Our Reference : 44100762 CB_L01
Your Reference : 14/3/2/1/R46-84

Subject: Traffic Impact Assessment: Proposed Township Establishment on Riverside View Extension 84 – Response to JRA Comments

RIVERSIDE VIEW EXTENSION 84: TRAFFIC IMPACT ASSESSMENT

Graph 1: Roundabout Performance

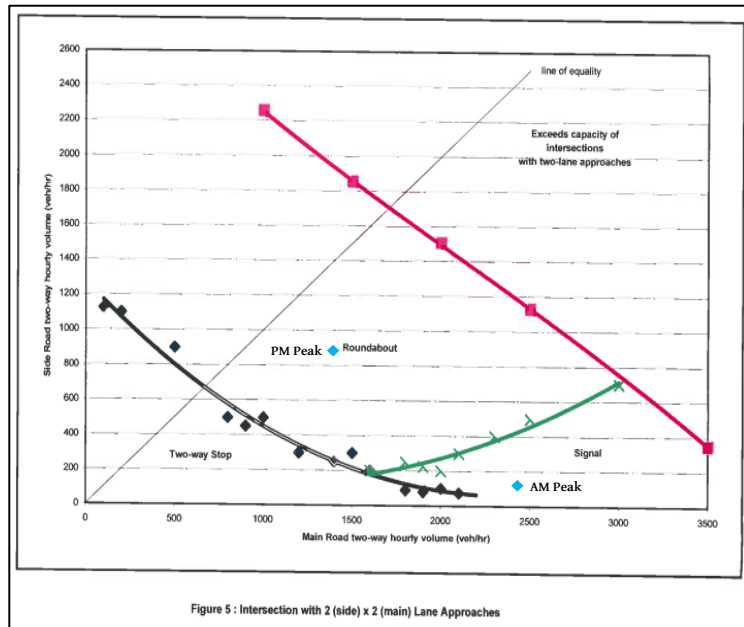
JRA questioned the capacity analysis of the roundabout intersection of Porcupine Park Avenue and View Road. Given the high number of traffic volumes of conflicting movements at the roundabout, JRA requested a further review of whether the roundabout will operate at acceptable levels of service.

The GDRT Guidelines for Roundabouts on Provincial Roads in Gauteng (BB12) document was used to determine the performance of the roundabout intersection. The main road (Porcupine Park Avenue) carries 2471 and 1473 peak hour traffic volumes during the AM and PM peak hour respectively. The side road (View Road) carries 157 and 841 peak hour trips during the AM and PM peak hour respectively.

According to the guideline document, a traffic signal is preferred instead of a roundabout when the traffic volumes are unbalanced and 80% or more of the traffic is on the main road. The traffic volumes on the main road are 94% during the AM peak hour and 64% during the PM peak hour. The traffic volumes are plotted on the graph below.

According to the above graph, the roundabout is performing at acceptable levels of service during the PM peak hour and unacceptable levels of service during the AM peak hour.

Figure 1: Proposed intersection layout

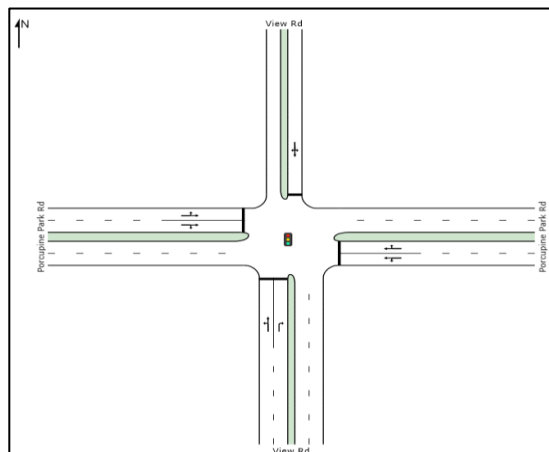
4. The department finds no analysis of any of the proposed access arrangements and questions the analysis of the external road network. The consultant is requested to arrange a meeting with this department to clarify the analysis associated with the proposed development.

5.2 Traffic signal

The roundabout intersection was re-analysed with a traffic signal configuration. The traffic volumes as depicted on Figure 4 of the original TIA were used as input. Detailed SIDRA results are attached in **Annexure E**. Capacity analysis results are indicated on **Table 2** below.

The proposed intersection layout is indicated on **Figure 1** below

PROPOSED TOWNSHIP
RIVERSIDE VIEW EXTENSION 84
 PROPOSAL

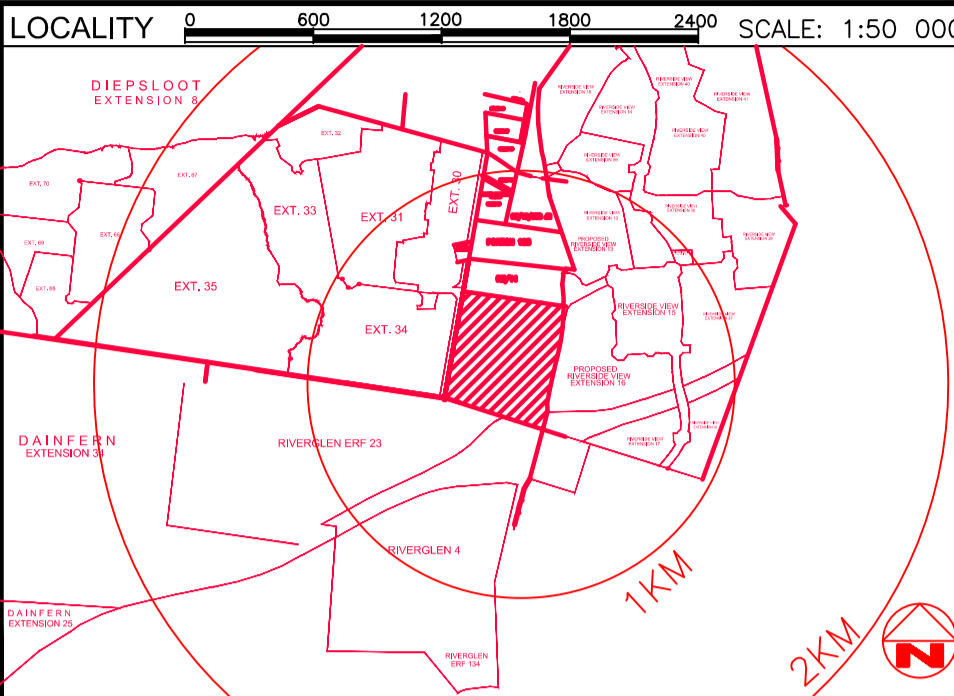
1. Reference is made to the township layout for the positions of the proposed accesses. No clear access position on View Avenue is indicated on the township layout; the proposed right of way servitude over the flood line providing access to erf 2 is unclear and appears to intersect with Porcupine Avenue; the proposed southern access is also not shown. No proof of a servitude over Erf 23 Riverglen is provided in support of this southern access; no access layouts are provided etc.

2.1 Positions of accesses

The proposed township will be served by three accesses as indicated on the amended township layout (see **Annexure C**) and are detailed below:

(a) Access off View Road

The access is situated on the western boundary of the property, approximately 150m south of the intersection of Porcupine Park Avenue and View Road directly opposite the Eskom substation site access.

(b) Second access off View Road

The access is situated on the western boundary of the property, approximately 300m south of the intersection of Porcupine Park Avenue and View Road directly opposite the existing Eskom substation site access.

(c) Southern access

This access will be an internal link road from the existing Steyn City. This is considered the main access to the township as a large number of trip generated by the proposed development are expected to originate from within Steyn City and will make use of this access.
